Re: **Rosemont Subdivision**
Response Letter
Project Number 2130073.00

In response to your plan review checklist dated July 30, 2013, we have addressed the items below, with our responses following your comments.

SUBDIVISION RESUBMITTAL - AUGUST 28, 2013

1 PROPOSED ROSEMONT ROAD SECTION
 C6.0 N.T.S. 1:1

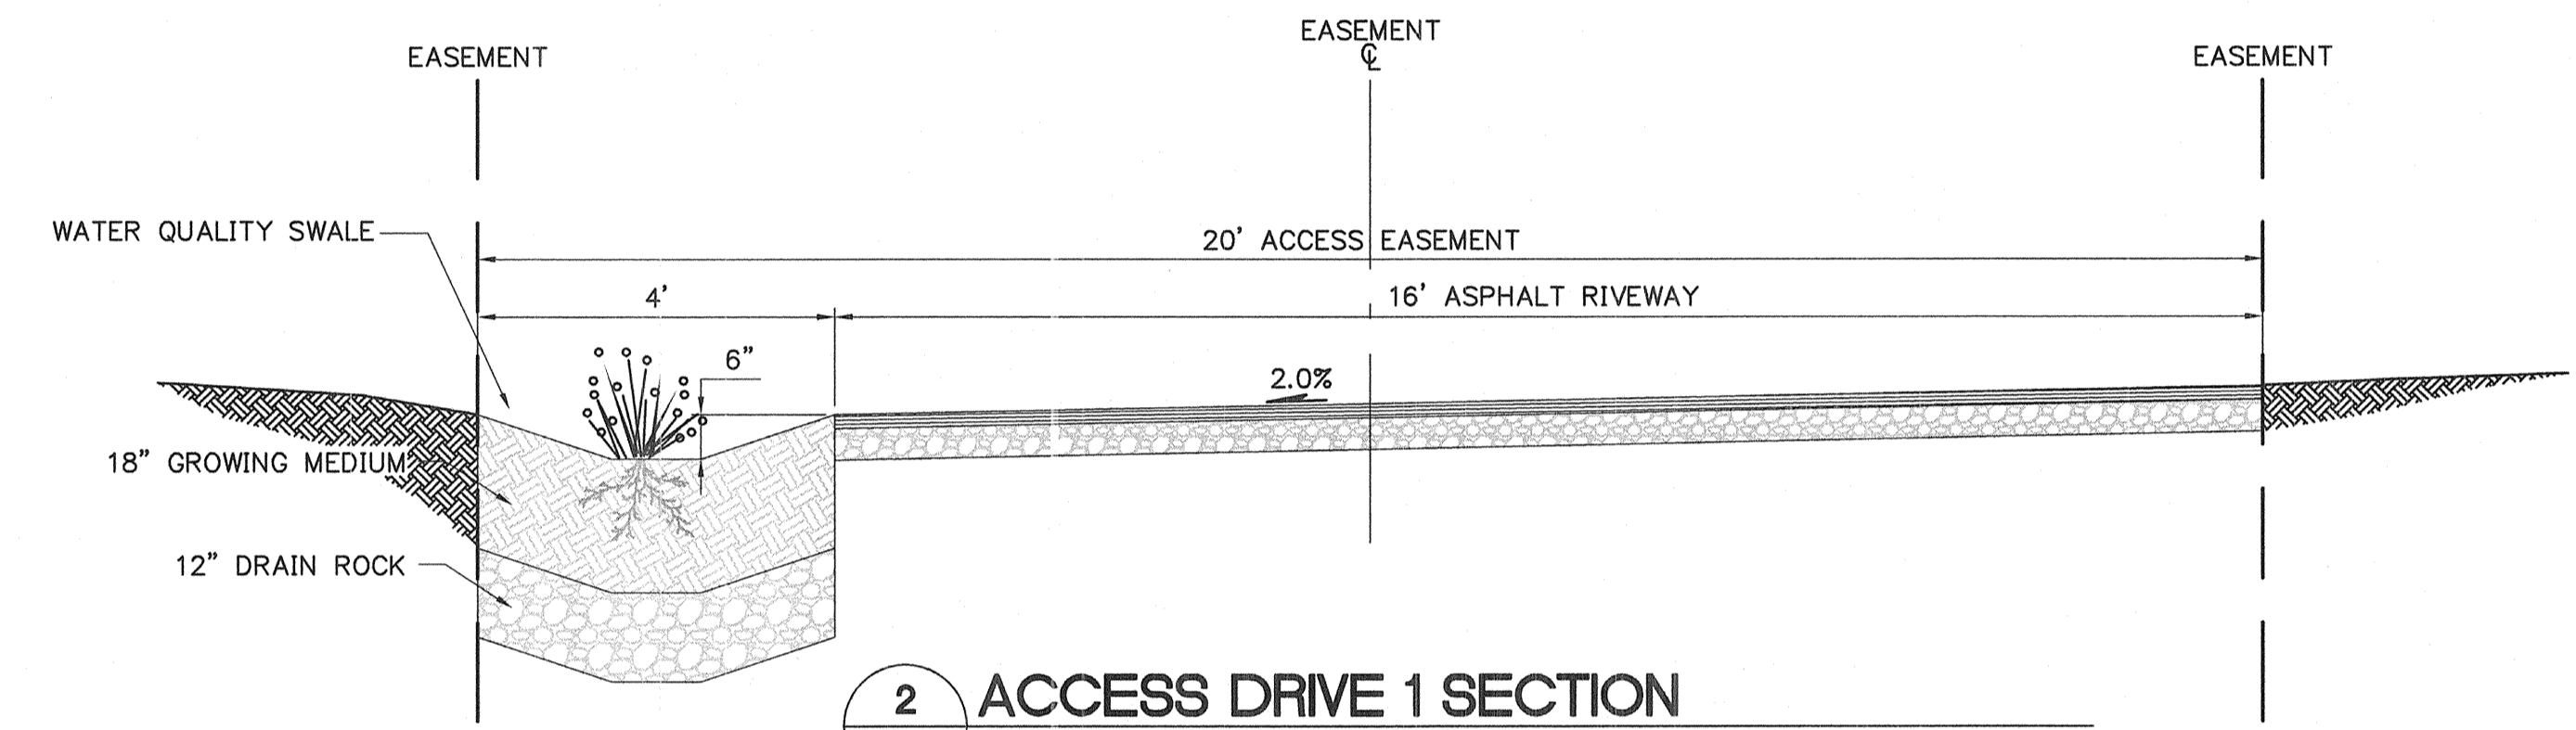
13. *Provide a cross section for Rosemont Rd improvement*

Response: A cross section of Rosemont Road improvements has been added to C6.0.

1
C10.0
ROSEMONT ROAD LIGHTING PLAN
1"=20'

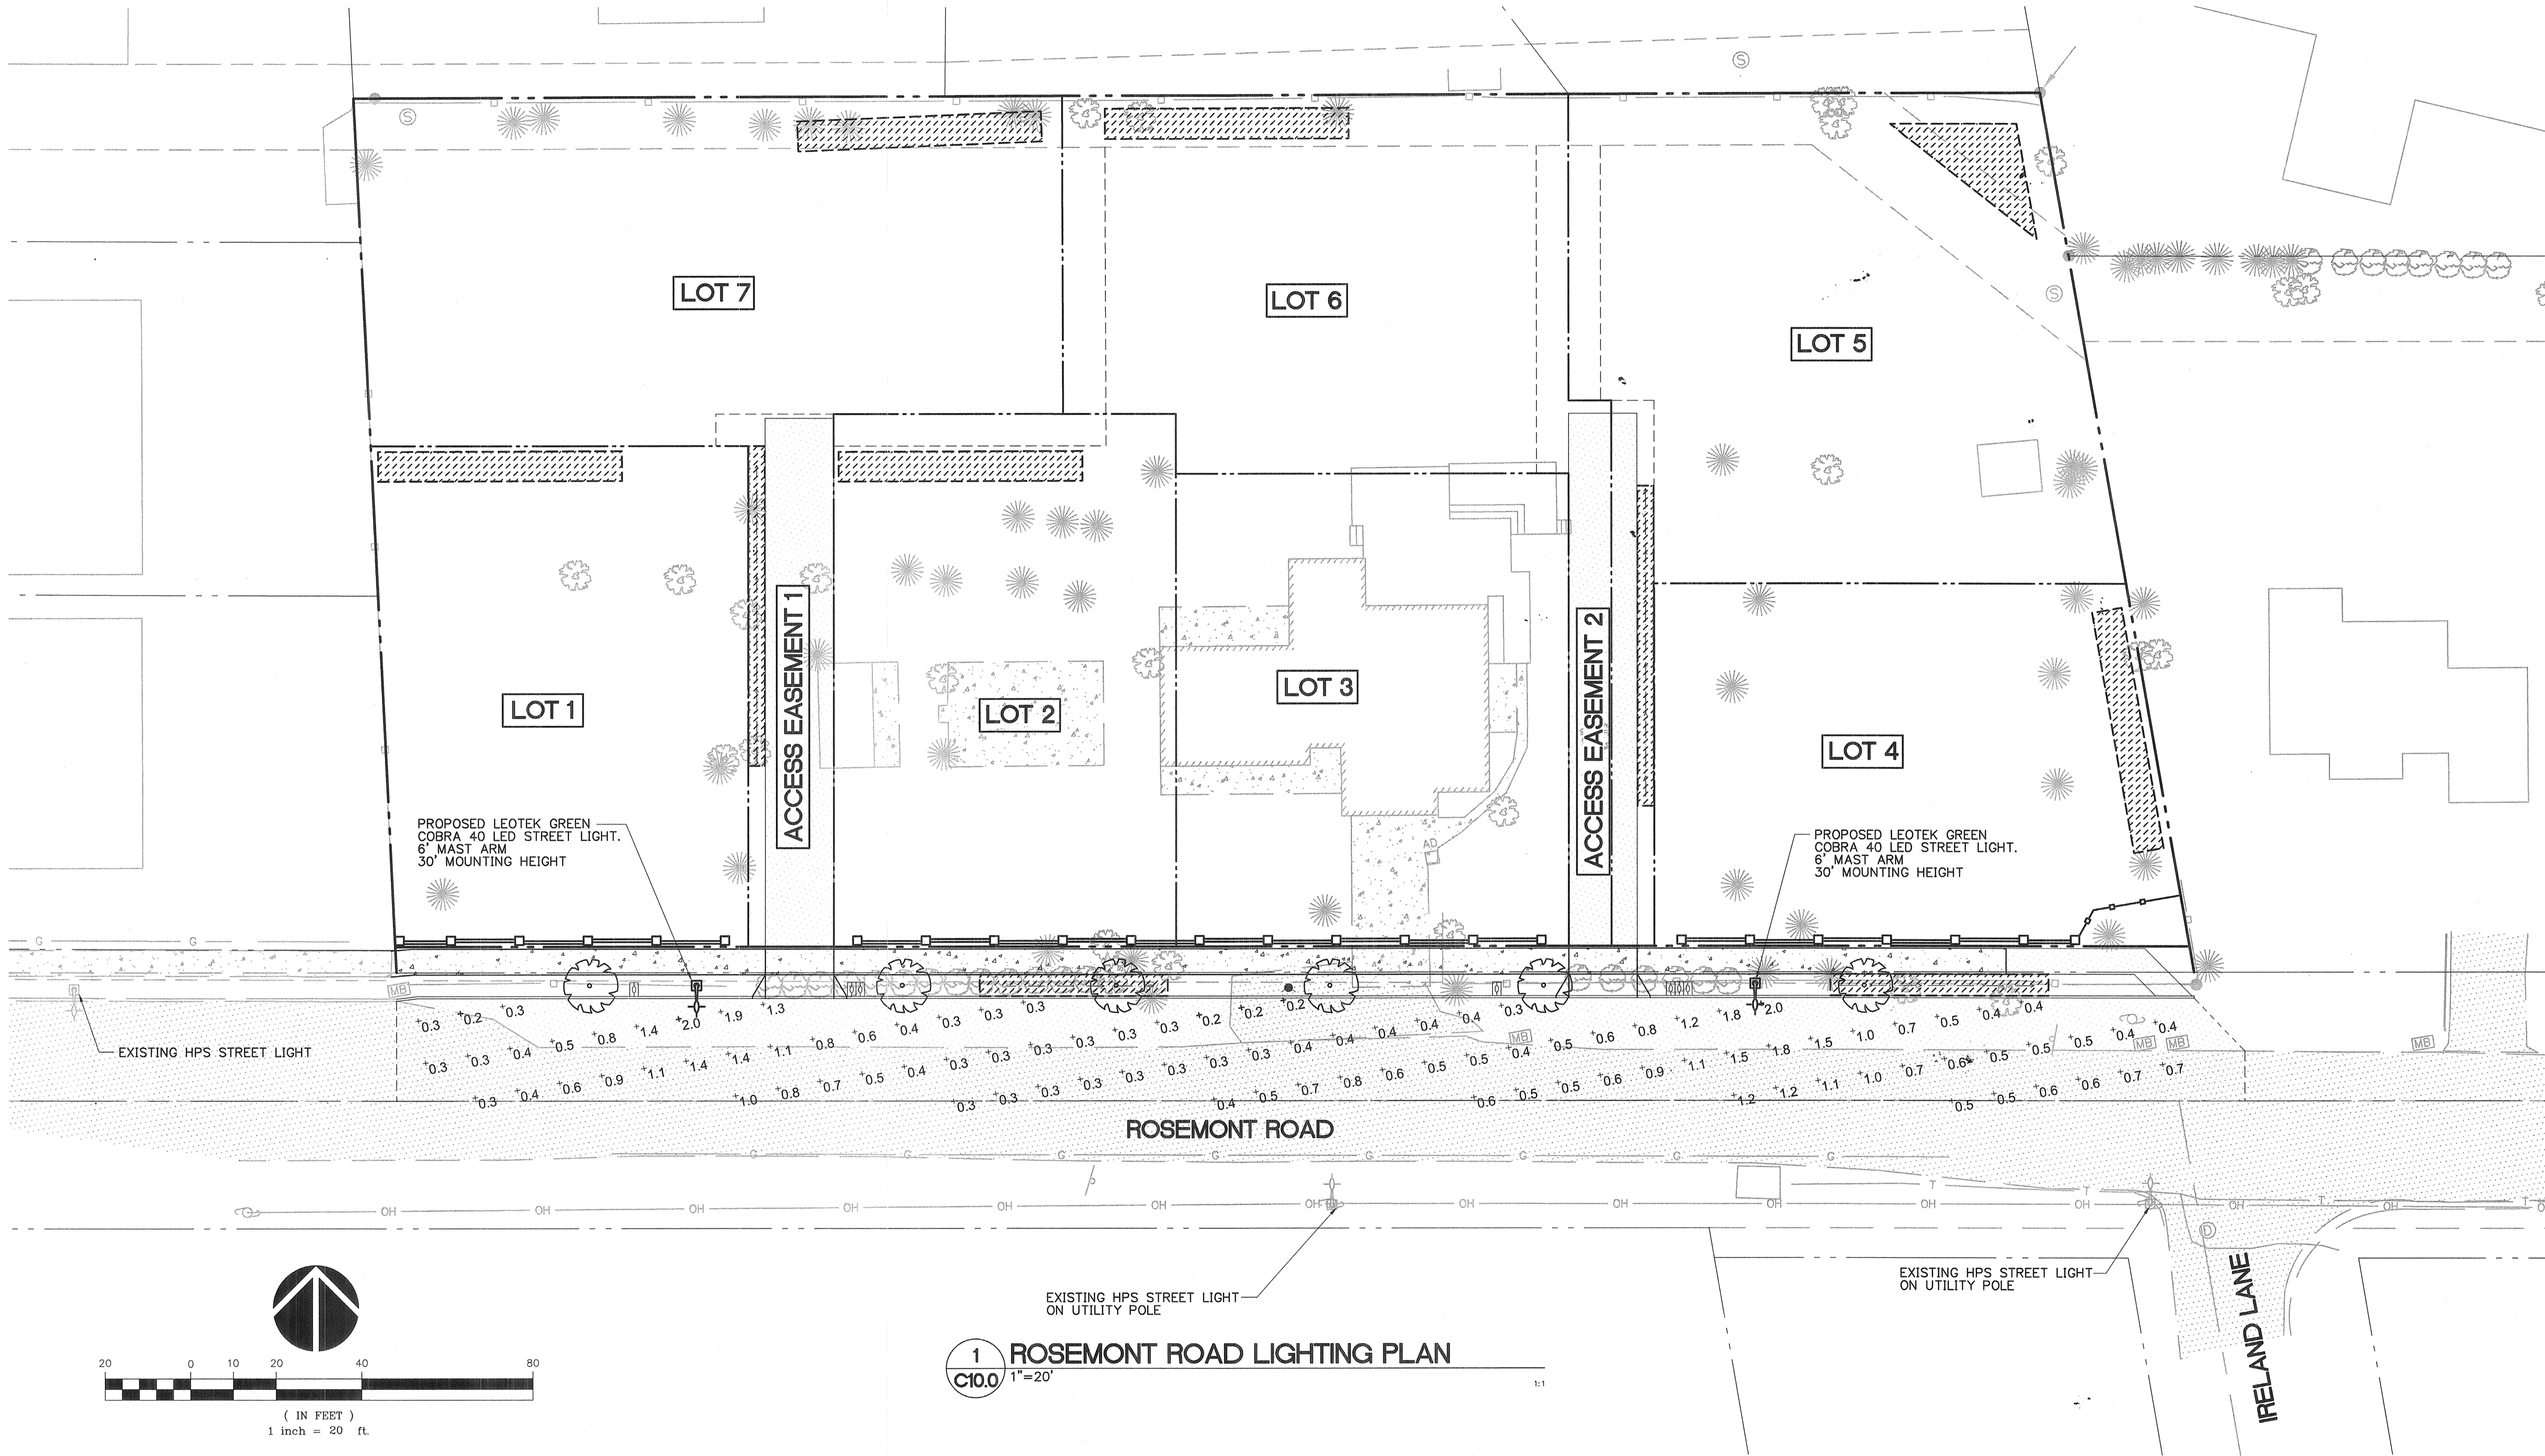
12. *Provide street lighting plan*

Response: See C10.0 for proposed street lighting plan on Rosemont Road.
